JOB BAPTIST PRIMARY CARE-JULINGTON CREEK
LOCATION
CUSTOMER
DRWG. COVERS ISO VIEW

JOB NO. 21-035
DRWG. NO. A-ISO

EAGLE CREEK - LOT 2
ISOMETRIC VIEW

ROOF DECK FRAMING PLAN

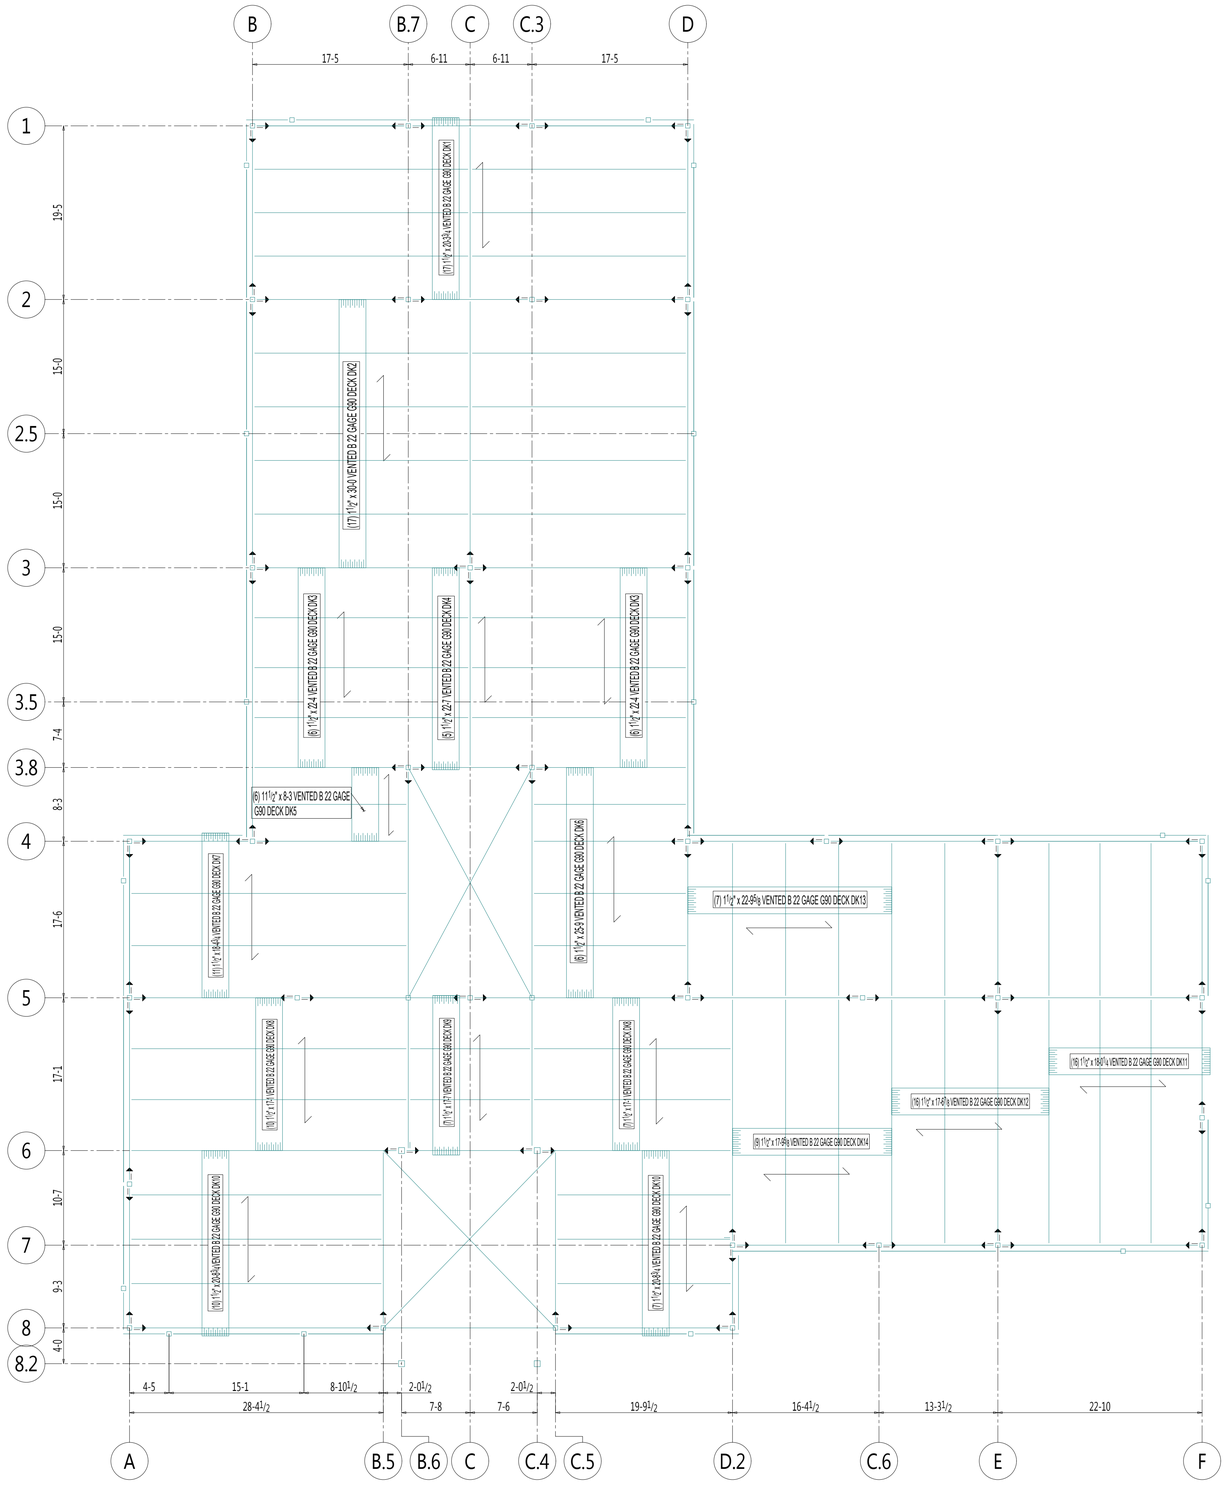
APPROVER PLEASE VERIFY FINISH.

ROOF FRAMING PLAN

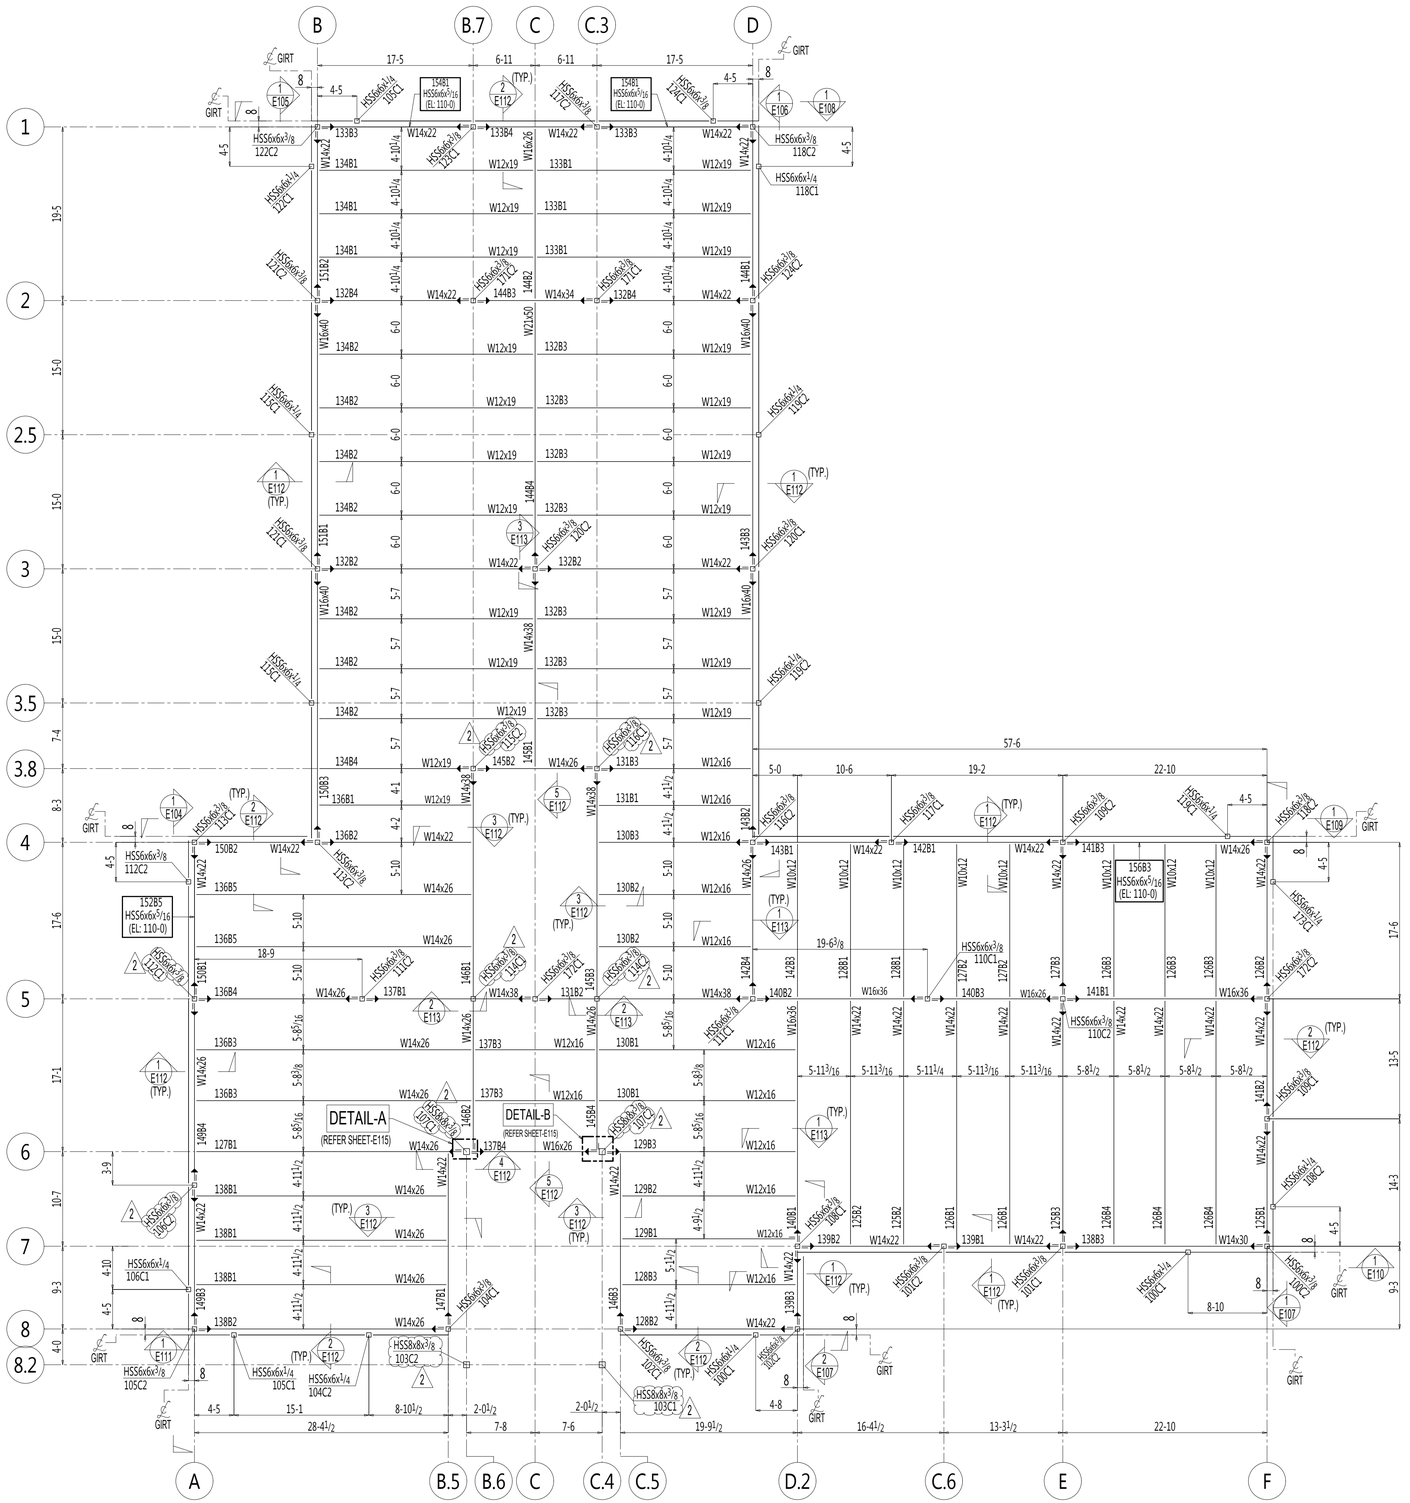
APPROVER PLEASE VERIFY FINISH.

DECK FINISH: GALVANIZED

LEVEL 2
PARTIAL MISC. PLAN

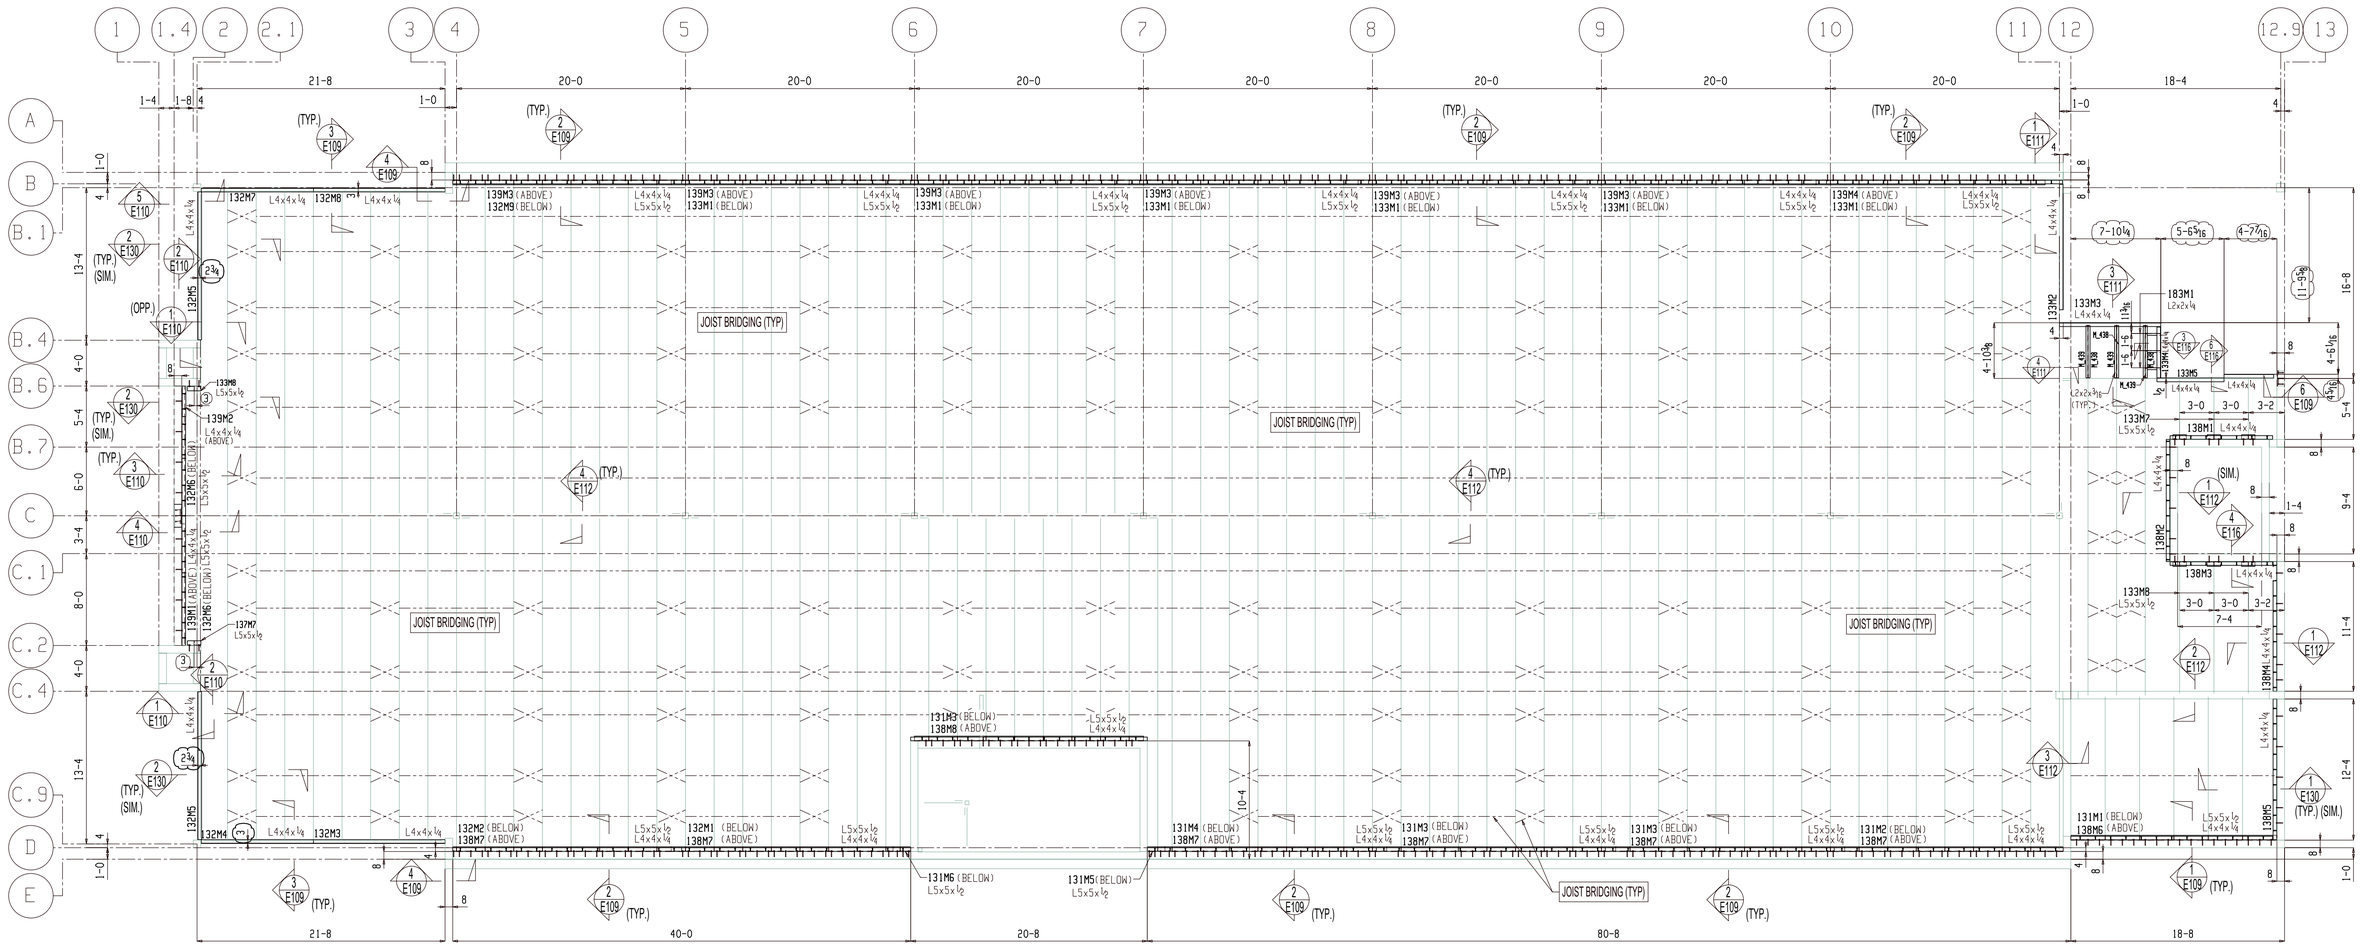
APPROVER PLEASE VERIFY CLOUDED DIMENSIONS.

ROOF FRAMING PLAN

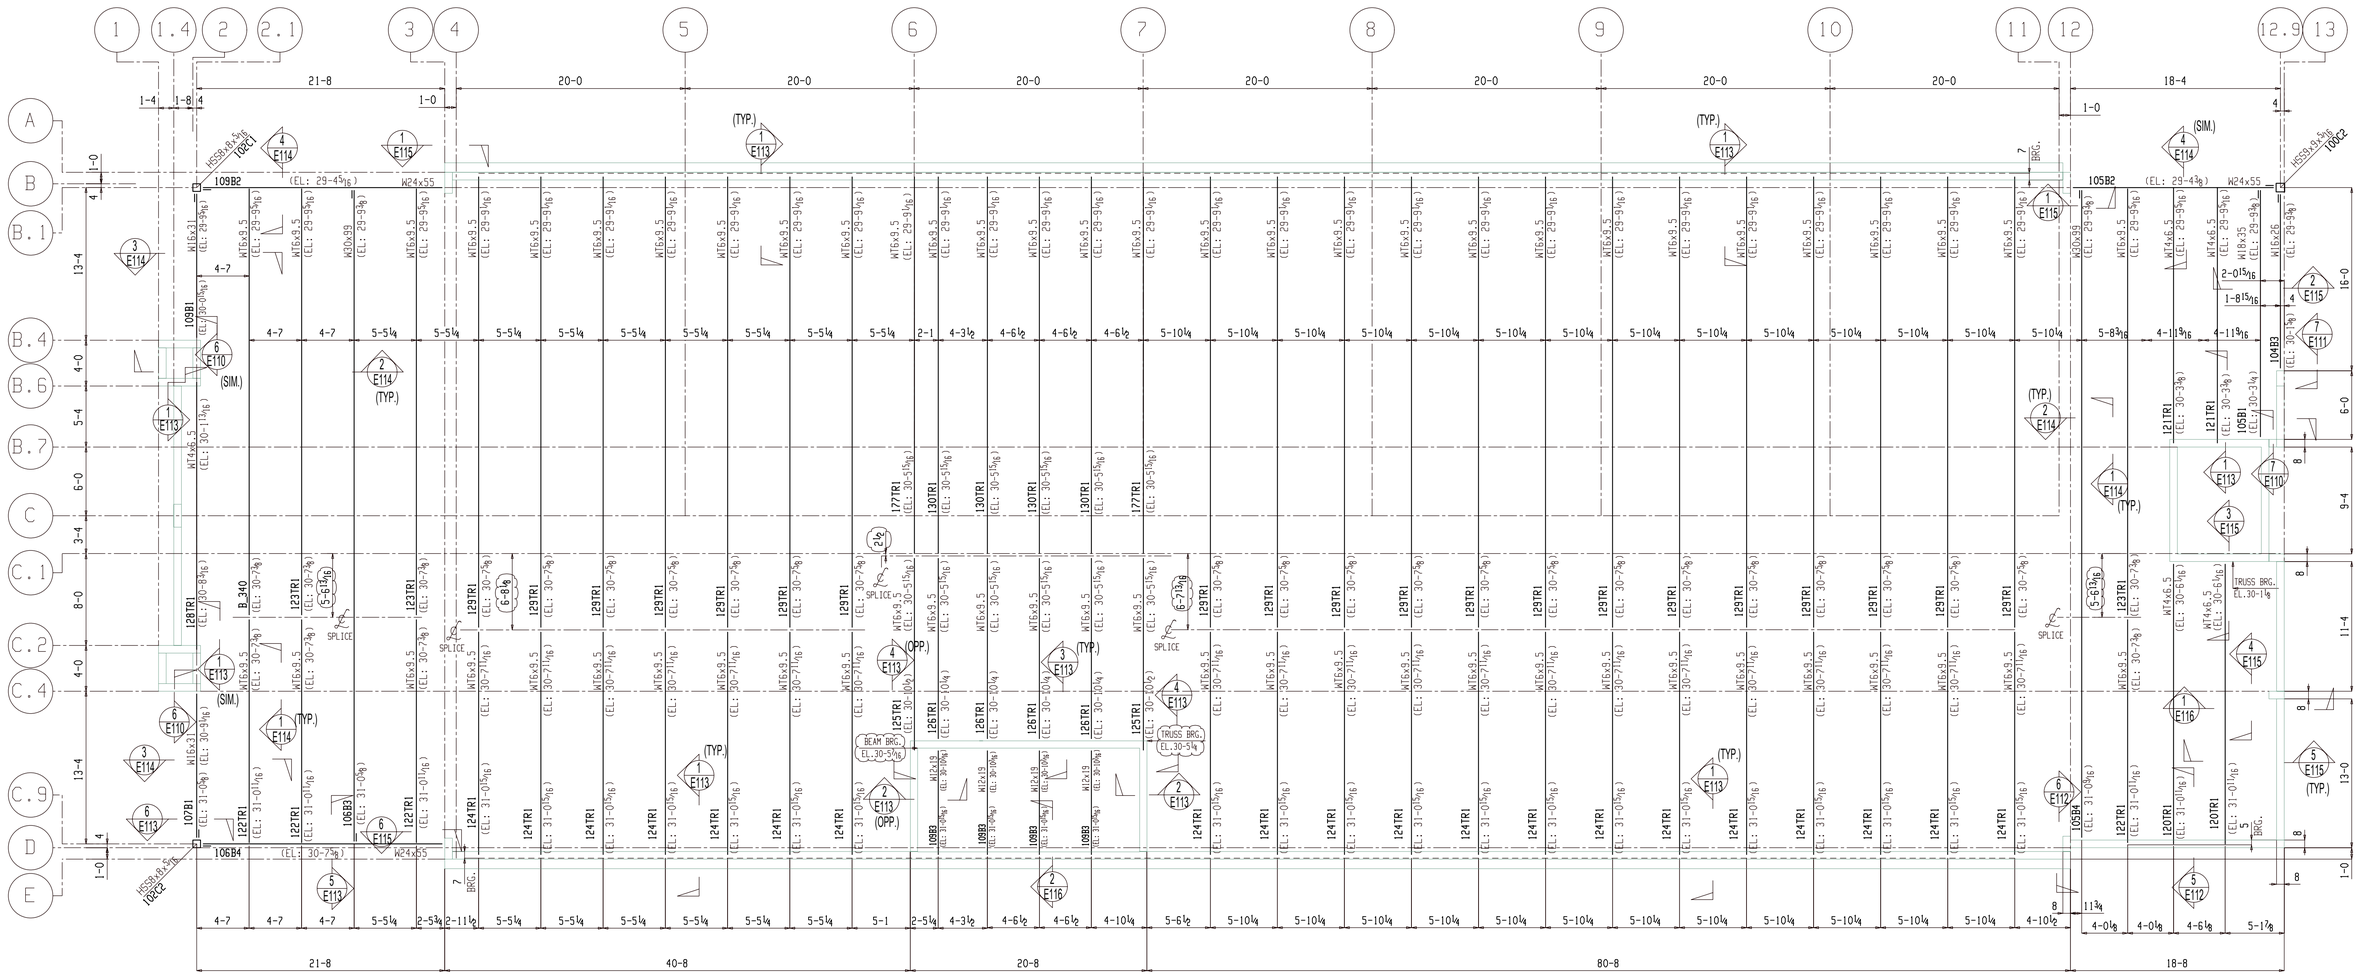
APPROVER PLEASE VERIFY CLOUDED DIMENSIONS.

ROOF MISC. PLAN

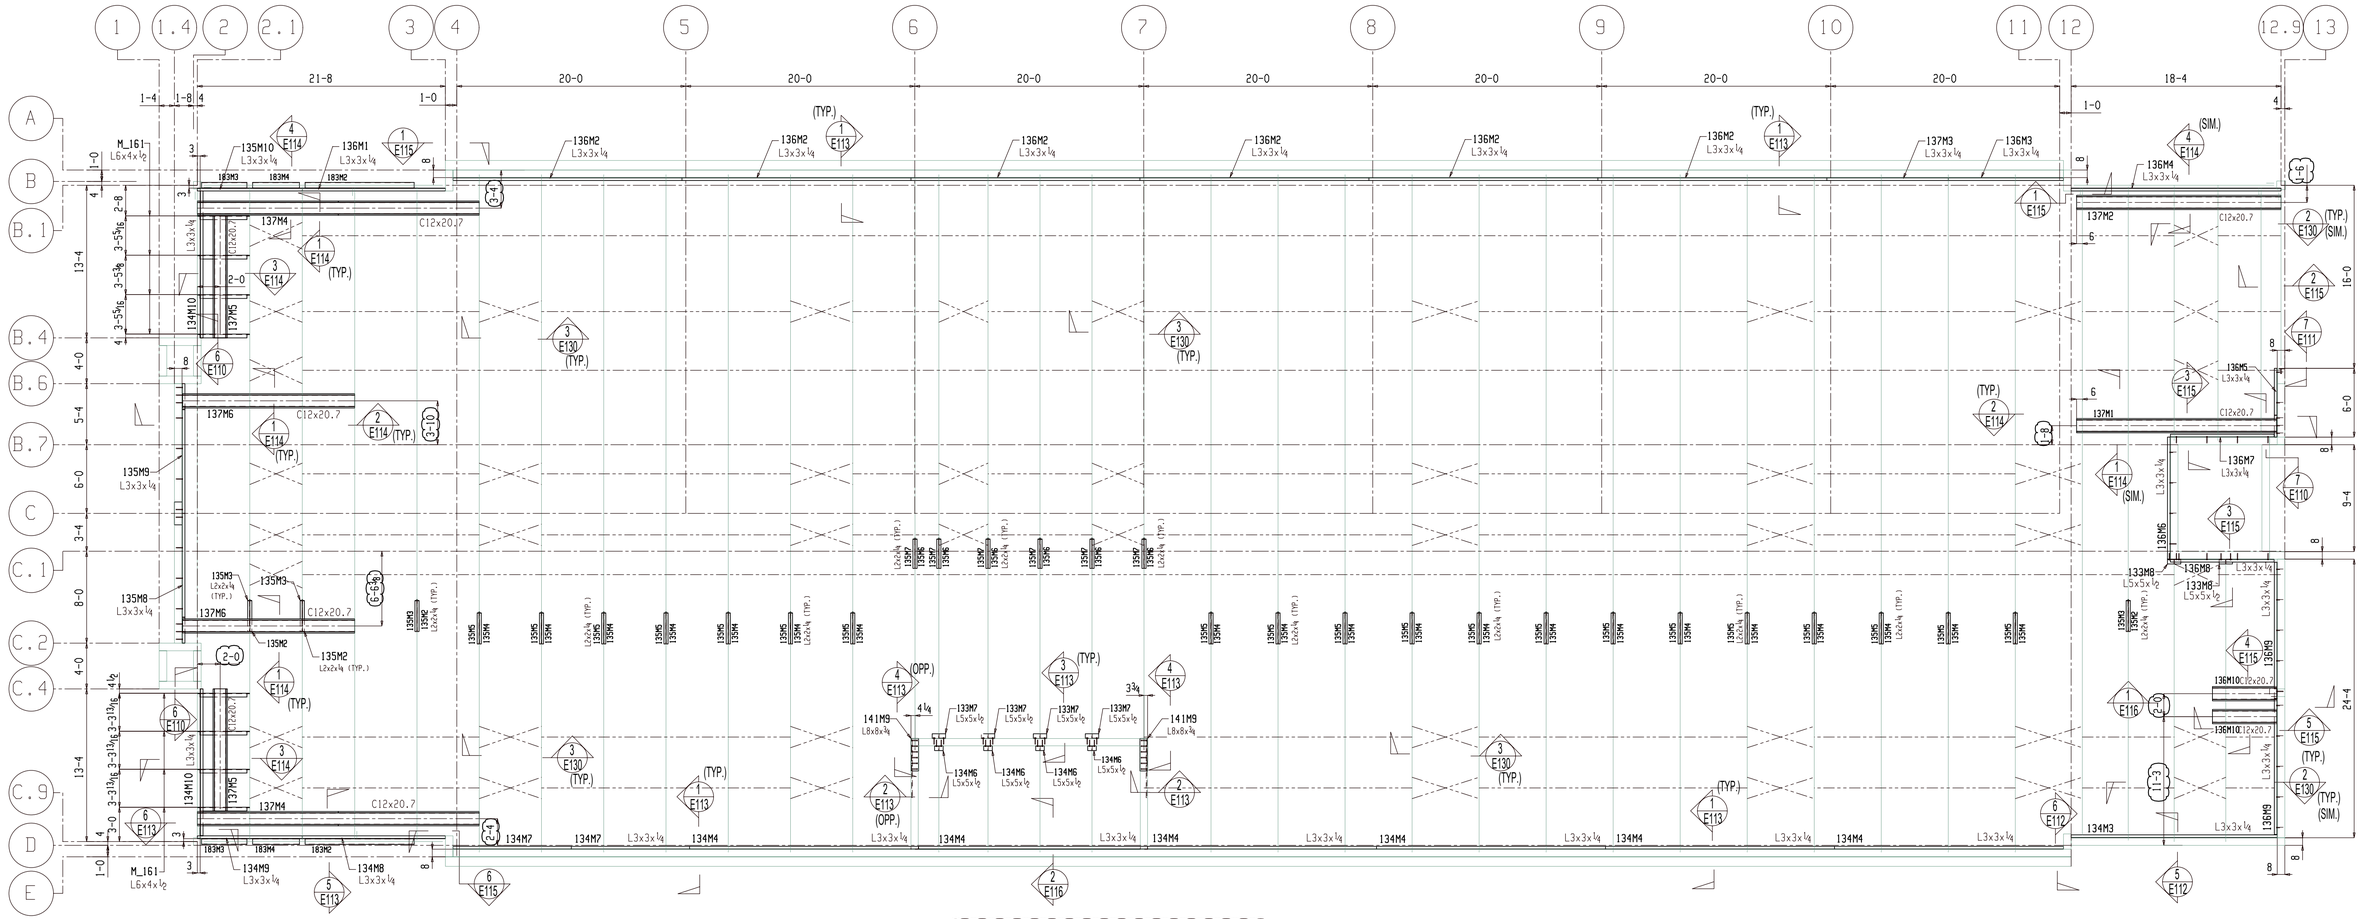
APPROVER PLEASE VERIFY CLOUDED DIMENSIONS.
